Michael W. Klemens, LLC
POB 432
Falls Village, CT 06031

April 15, 2015

Norman Fontaine, Chairperson
& Members of the Amenia Planning Board
4988 Rte. 22, Amenia, NY 12501

SEQRA Ecological Analysis: Parcel 1.

FIGURE 1
Vernal Pool Conservation Analysis
Silo Ridge
Amenia, New York

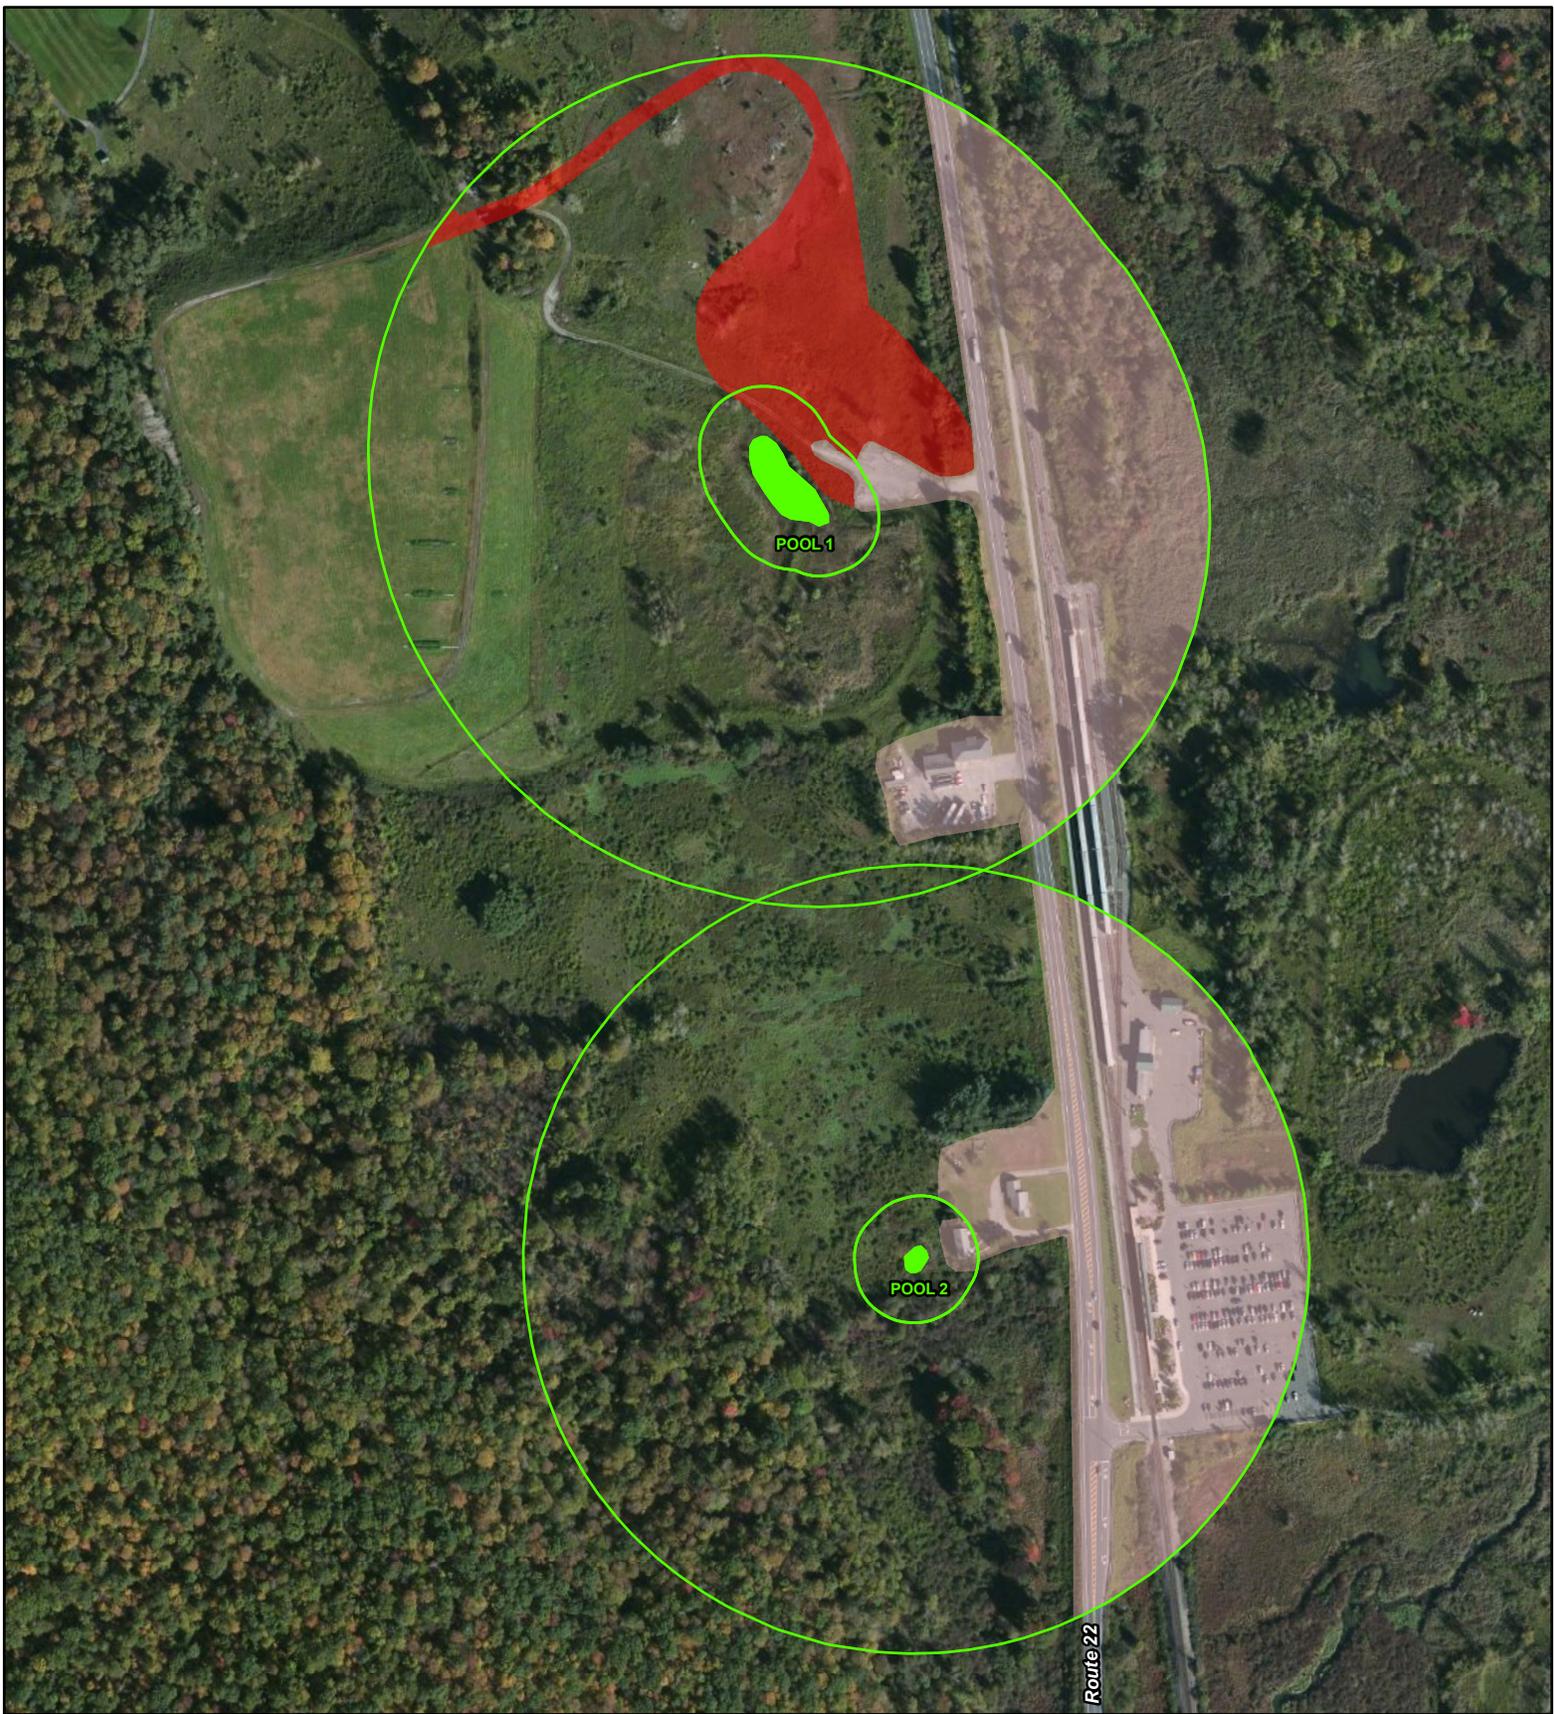
VHB field work in 2014 identified two vernal pools based on the presence of breeding obligate amphibian species using the presence of larvae and egg masses. One area of vernal pool activity was found imbedded in the large wetland on Parcel 1. It is termed a cryptic vernal pool because it is a subset of a much larger wetland system (i.e., where vernal pool obligate amphibians were breeding). It is referred to as Pool 1 in my analysis. The other vernal pool (Pool 2) is a classic depression vernal pool located on Parcel 2. In the case of a classic depression vernal pool, the entire wetland corresponds to the vernal pool. Vernal pools function together as a meta-population, if their 750 foot habitat zones intersect these pools are analyzed in tandem. This is illustrated in Figure 1.

Wood frogs were confirmed breeding in Vernal Pool 1, however there was no estimate of the population size based upon egg mass counts. Vernal Pool 2 was a highly productive pool. On April 18, 2014 VHB

scientists counted 79 wood frog egg masses and 21 spotted salamander egg masses. Pool 2 has a much higher conservation value than Vernal Pool 1 because it has two species of amphibians breeding in it and significant egg production of both species. The ecological integrity of Vernal Pool 2 is greatly enhanced by the presence of a significant amount of forest within the 750-foot vernal pool life zone. This forested area is critical habitat, especially for spotted salamanders. Wood frogs are better able to exploit grassy open habitats, which is the bulk of the habitat that lies within the 750-foot vernal pool life zone of Pool 1. It is not surprising therefore that the significant vernal pool resource is Pool 2, with a satellite population of wood frogs in Pool 1 which is sub-optimal habitat. The proposed development of Parcel 1 is illustrated in Table 1. The current level of development in the vernal pool envelope (0-100 feet from the pool) is 7% and that is proposed to be increased by 24% to a total of 32%. This is by numerical standards a significant adverse impact. However, that development is occurring already in portions of the envelope that could be considered not very desirable from a wood frog's ecological perspective. The most ecologically valuable portion of the envelope, that which backs up to the west of the pool remains intact. The critical upland habitat 100-750 feet is currently at 27% developed, largely because a portion of that habitat is cut off from the pool by Rte. 22 and is considered lost to amphibians using that pool. That will increase by 10% to 36% post development. By numerical standards, this is a minor increase as the 25% threshold for development has already been exceeded by the existing site conditions.

In conclusion, I consider the proposed development on Parcel 1 to have a *de minimus* impact to the overall vernal pool resources on the site for the following reasons. A large cluster of vernal pools is protected on the open space forest on the Silo Ridge development. As significant vernal pool occurs on Parcel 2 and future development of Parcel 2 should be mindful of the need to protect the forested areas within the 750-foot vernal pool life zone. Compared to the high quality of the ridge top pools and Vernal Pool 2, and with my own examination of Vernal Pool 1 in 2013, I consider this to be a minor satellite population of wood frogs originating (most likely) by emigration from Pool 2. While arguably the development around Pool 1 is undesirable from a vernal pool conservation perspective, examining the quality of that habitat and its productivity, with the other vernal pools to be conserved on the site as a whole, it's my professional opinion that on balance, the Silo Ridge project has fully protected the important (in terms of biological productivity and landscape integrity) vernal pools on the development site (which includes a small portion of Parcel 1).
